UNITED STATES PATENT AND TRADEMARK OFFICE

APPLICATION NO.	FILING DATE	FIRST NAMED INVENTOR	ATTORNEY DOCKET NO.	CONFIRMATION NO.
10/750,572	12/31/2003	Ali Keshavarzi	P18062	5687

Office Action Summary

DETAILED OFFICE ACTION

FIG. 13

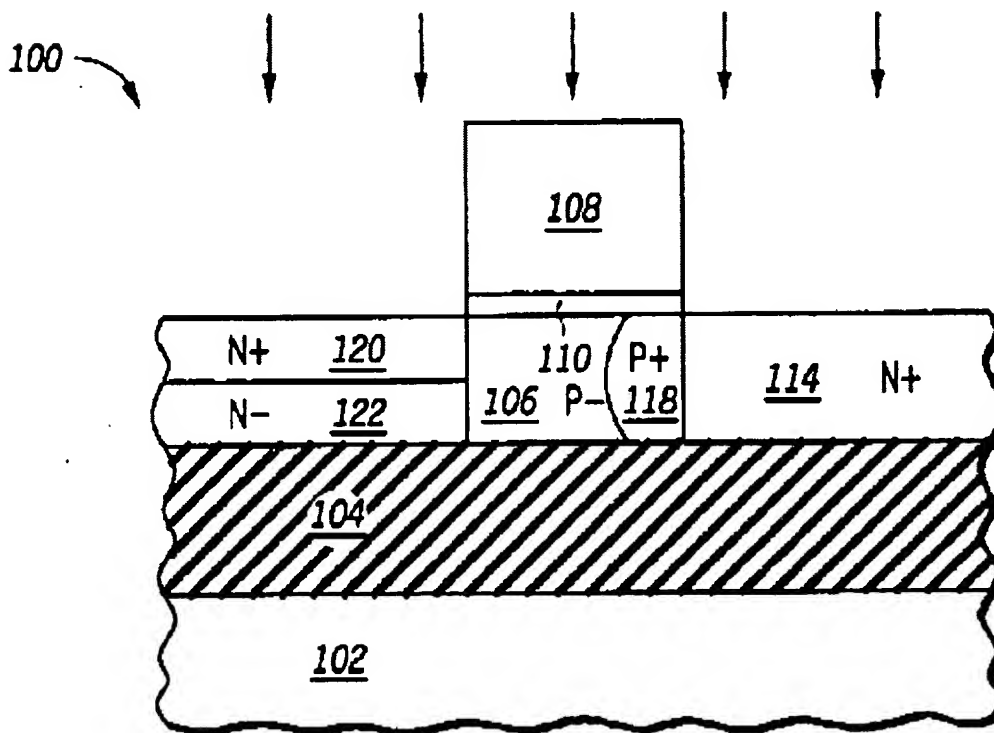
Burnett discloses (in fig 13, column 1 lines 59-60) a memory cell comprising: a body region (region 106 in fig 13) doped with charge carriers of a first type; a source region (source region 120,122) disposed in the body region, the source region doped with charge carriers of a second type; and a drain region disposed in the body region, the drain region (drain region doped with charge carriers of the second type, wherein the body region and the source region form a first junction, wherein the body region and the drain region form a second junction, and wherein a conductivity of the first junction from the body region to the source region in a case that the first junction is unbiased is substantially less than a conductivity of the second junction from the body region to the drain region in a case that the second junction is unbiased. Noted even though Burnett does not mentioned the limitation “ wherein the body region and the source region form a first junction, wherein the body region and the drain region form a second junction, and wherein a conductivity of the first junction from the body region to the source region in a case that the first junction is unbiased is substantially less than a conductivity of the second junction from the body region to the drain region in a case that the second junction is unbiased. “; the structure discloses by Burnett in fig 13 fully anticipate this limitation of claim 1 due to the doping profile of the source

(N+ and N- doped) compared with the drain (N+ doped) therefore the conductivity of the drain is more than the conductivity of the source when unbiased.

Burnett discloses (in fig.13,region 118) a halo implant region to form at least a portion of the second junction and the Halo implant is more heavily doped (P + doped) than the body region 106 (P- doped)
